CALIFORNIA COASTAL COMMISSION

SUBJECT: **Proposed Major Amendment (2-97) to the University of California Santa Barbara Certified Long Range Development Plan for Public Hearing and Commission Action at the May 13, 1997 Commission Meeting in Santa Barbara.**

SUMMARY OF STAFF RECOMMENDATION

EXHIBIT 3b
UCSB LRDPA 2-97
Site Plan

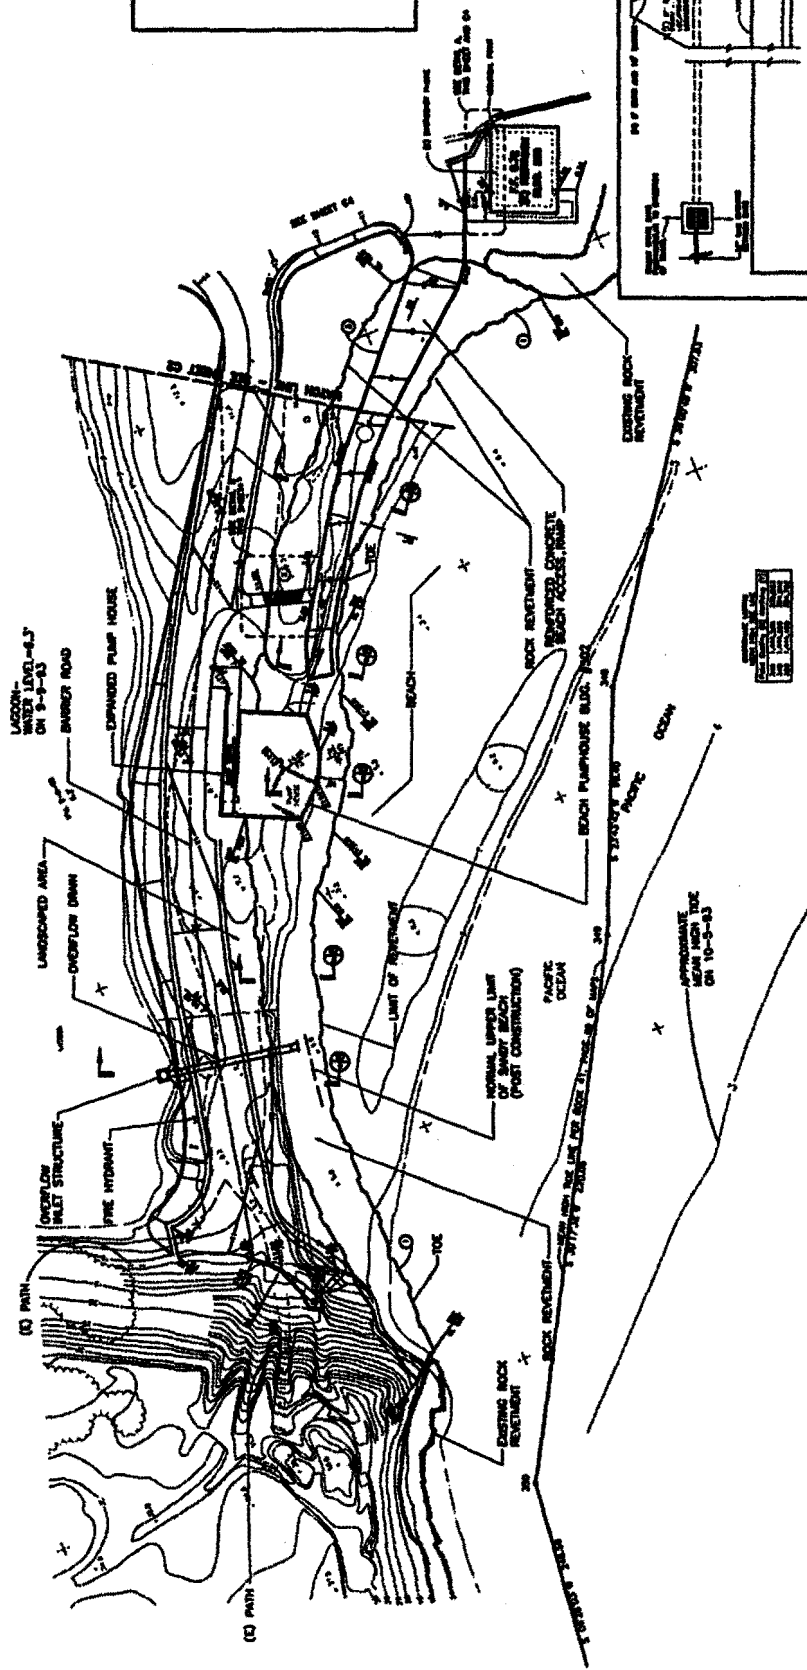
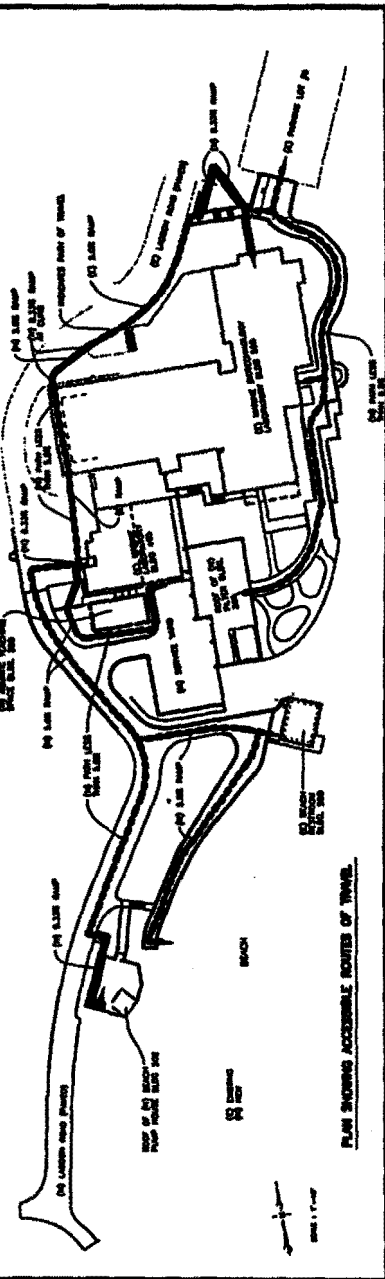
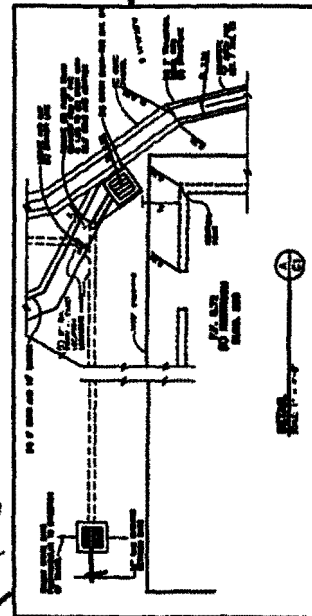
The University is also proposing to reroute the last link of the bluff top path to the beach around the landward side of the Marine Biotechnology Laboratory (Exhibit 3b). The existing terminus of the bluff trail will remain open to the public. A new sidewalk will connect the bluff top path with the existing access road to the beach will be designed to allow for access by the physically challenged. The new configuration of the access trail is minor in nature, and will not result in a significant disruption to coastal access.

The University is also proposing to reroute the last link of the bluff top path to the beach around the landward side of the Marine Biotechnology Laboratory (see figure 3-5) in order to allow for greater security for the Marine Laboratory Service Yard. Rerouting the path will also allow for the provision of access for the physically challenged while reducing adverse impacts to coastal bluff habitat. The change in location is minor in nature and will not result in adverse impacts to public coastal access. The existing terminus of the bluff trail will remain open to the public. A new sidewalk will connect the bluff top path with the existing access road to the beach which will be designed to allow for access by the physically challenged.

The LRDP Figure 26, Coastal Access Improvements, identifies that the bluff top path that currently terminates at a seating area east of the Marine Biotechnology Laboratory would continue down the bluff face to the beach. In order to provide better security to the Marine Biotechnology Building yard which houses many of the components of the existing and proposed additions to the seawater renewal system such as storage tanks,

filters, pumps and distribution lines and to avoid further impacts to the fragile bluff face, the University is proposing to reroute the last link of the bluff top path to the beach around the landward side of the Marine Biotechnology Laboratory (Exhibit 3b). The existing terminus of the bluff trail will remain open to the public. The new configuration of the access trail is minor in nature, and will not result in a significant disruption to coastal access. In addition, the new sidewalk which will connect the bluff top path with the existing access road to the beach will be designed to allow for access by the physically challenged. Signs indicating public access to the coast will be posted along the new pathway. Modification six (6) is suggested in order to ensure that the above changes to coastal access are accurately reflected in the LRDP.

Update Figures 26 to include the proposed new improvements and include relocation of coastal access route to the beach from the bluff top path and parking lot 6.
